Certificate of Appropriateness

Property 2102 N. 2nd St.
Description of work General Exterior Repairs; Remove Substitute Siding; New Wood Windows;
 New Two Car Garage Slab

Date issued 2/2/2007 **PTS ID** 34668 COA-General Exterior Repairs

2012 N. 2nd

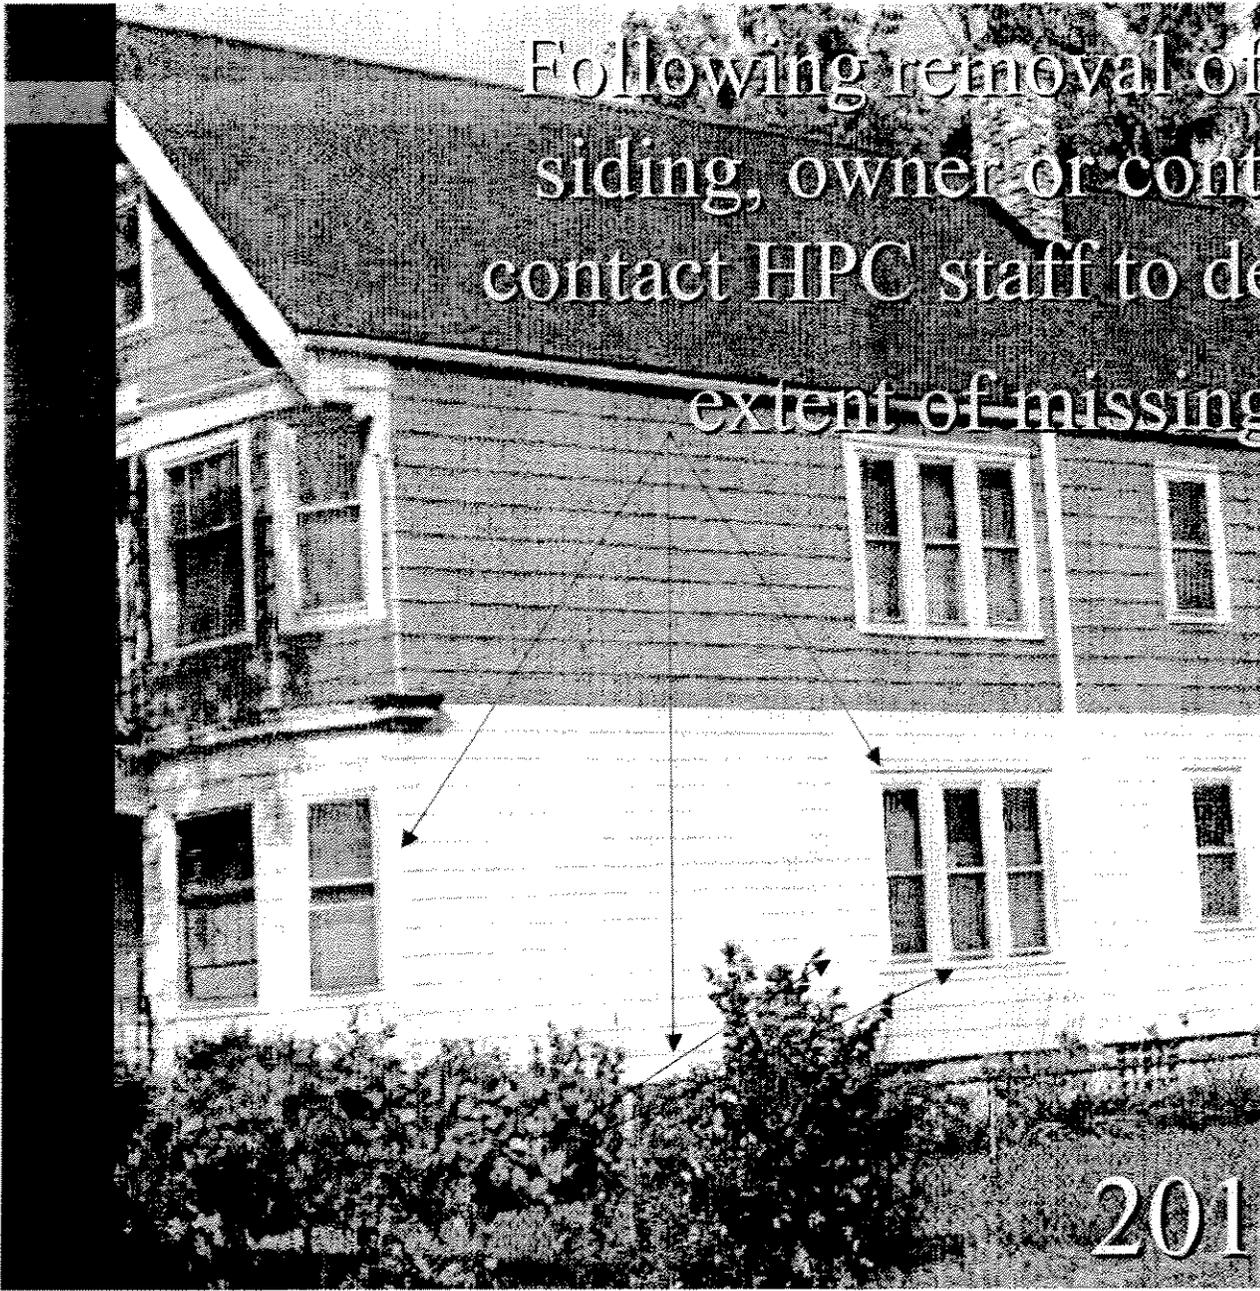
Remove existing substitute siding
and restore original wood siding
and trim beneath.

New wood
railings on
porches

Reopen historic
piano winds

Following removal of substitute siding, owner or contractor will contact HPC staff to determine the extent of missing trim.

Newel Post Design

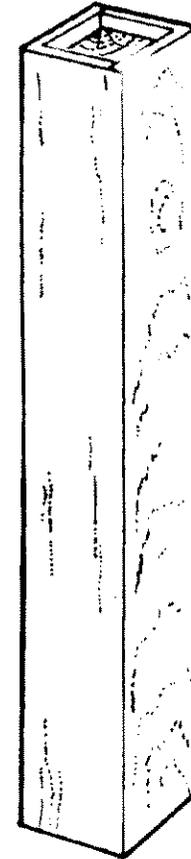
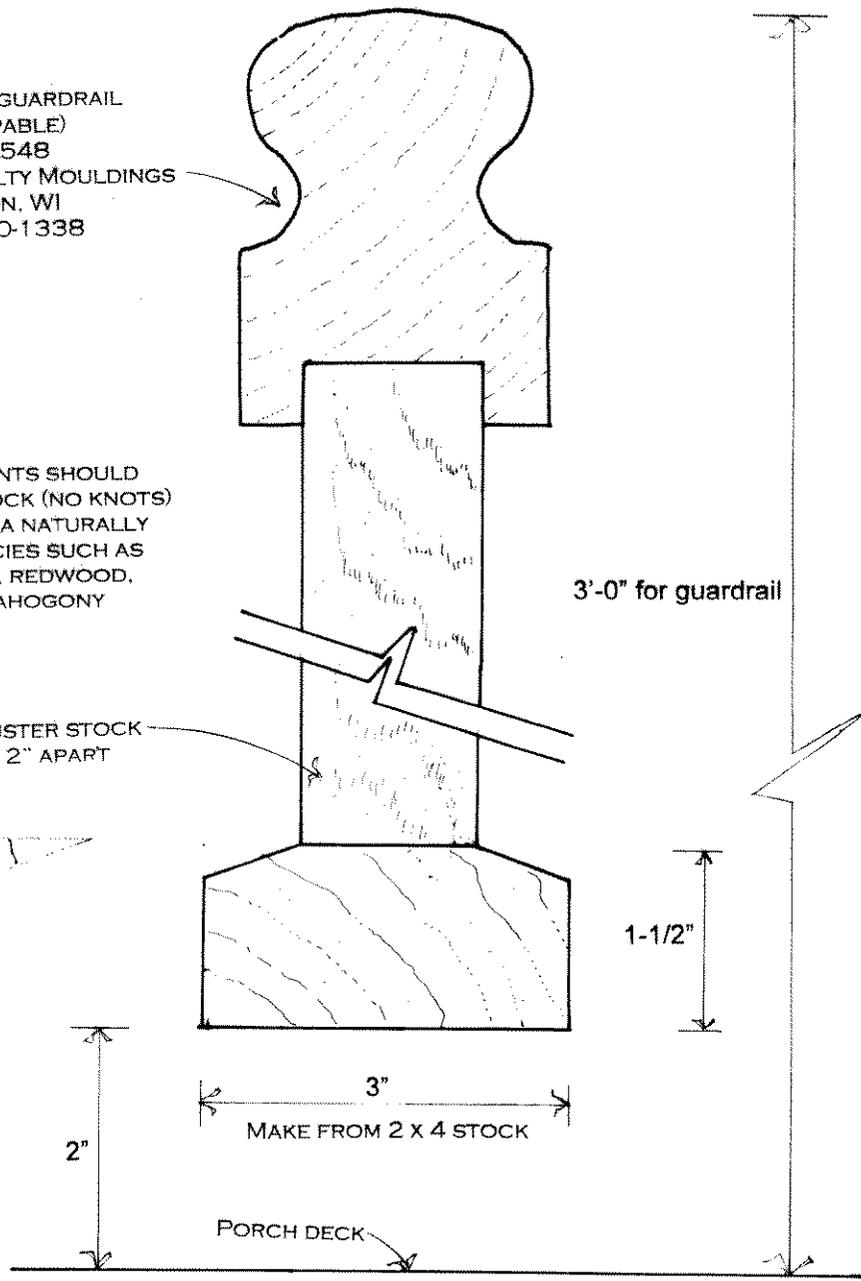
NEWEL POSTS FOR FRONT PORCH MAY BE EITHER THE SOLID TYPE SHOWN AT LEFT OR THE BUILT-UP BOX POST SHOWN AT RIGHT.

SOLID POSTS ARE 5-1/2" SQUARE AT THE BASE. THEY ARE AVAILABLE FROM WWW.CINDERWHIT.COM

SUBSTITUTIONS FOR THE SOLID POST MAY BE PERMITTED, BUT MUST FIRST BE APPROVED BY HPC STAFF. BOX POST MUST BE CONSTRUCTED EXACTLY AS SHOWN.

HANDRAIL/GUARDRAIL SECTION
FULL SIZE

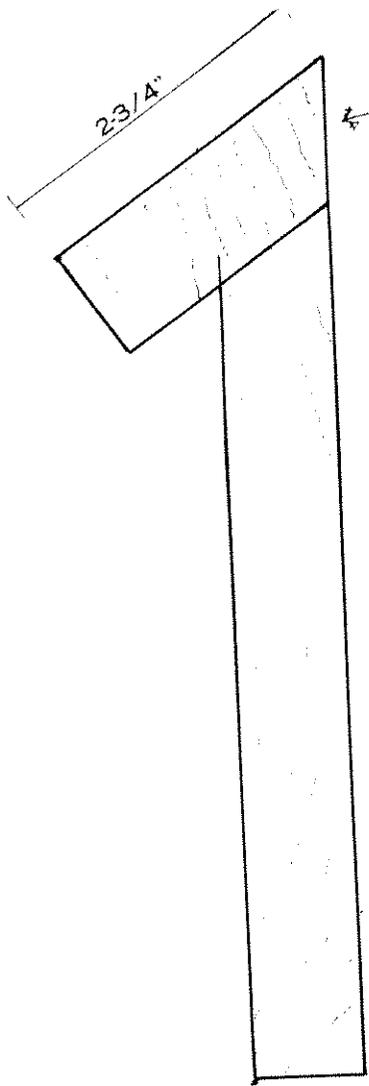
HANDRAIL/GUARDRAIL
(GRASPABLE)
#HR 548
CROWN SPECIALTY MOULDINGS
MILTON, WI
608-290-1338

ALL RAILING COMPONENTS SHOULD
BE MADE FROM CLEAR STOCK (NO KNOTS)
AND PREFERABLY FROM A NATURALLY
DECAY-RESISTANT SPECIES SUCH AS
RED CEDAR, CYPRESS, REDWOOD,
SPANISH CEDAR, MAHOGONY

2 x 2 BALUSTER STOCK
SPACED 2" APART

CORNER BOARD:
FULL SIZE

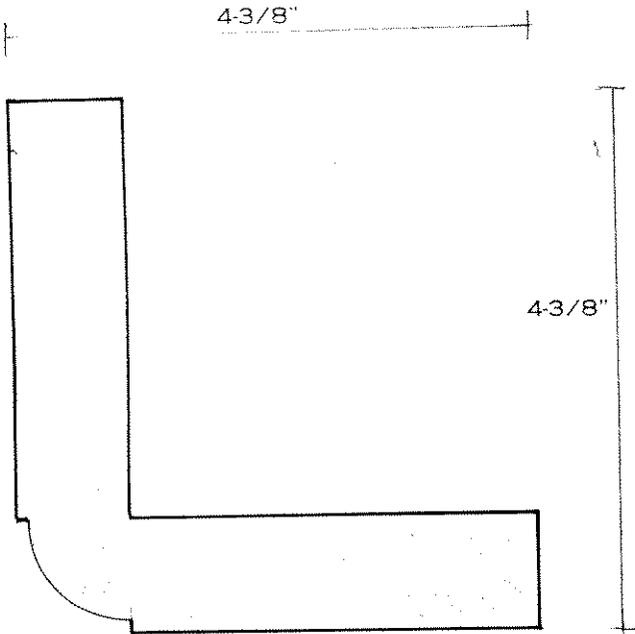
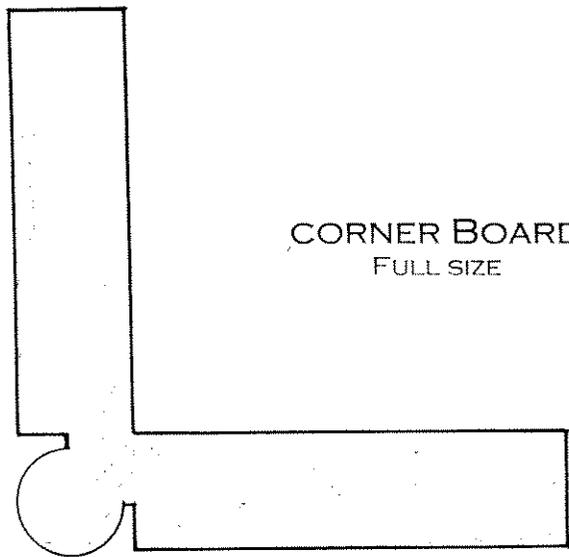
NOTE: 13/16" OR 3/4" MATERIAL
MAY BE USED FOR ANGLED BOARD

WATER TABLE
AT TOP OF FOUNDATION
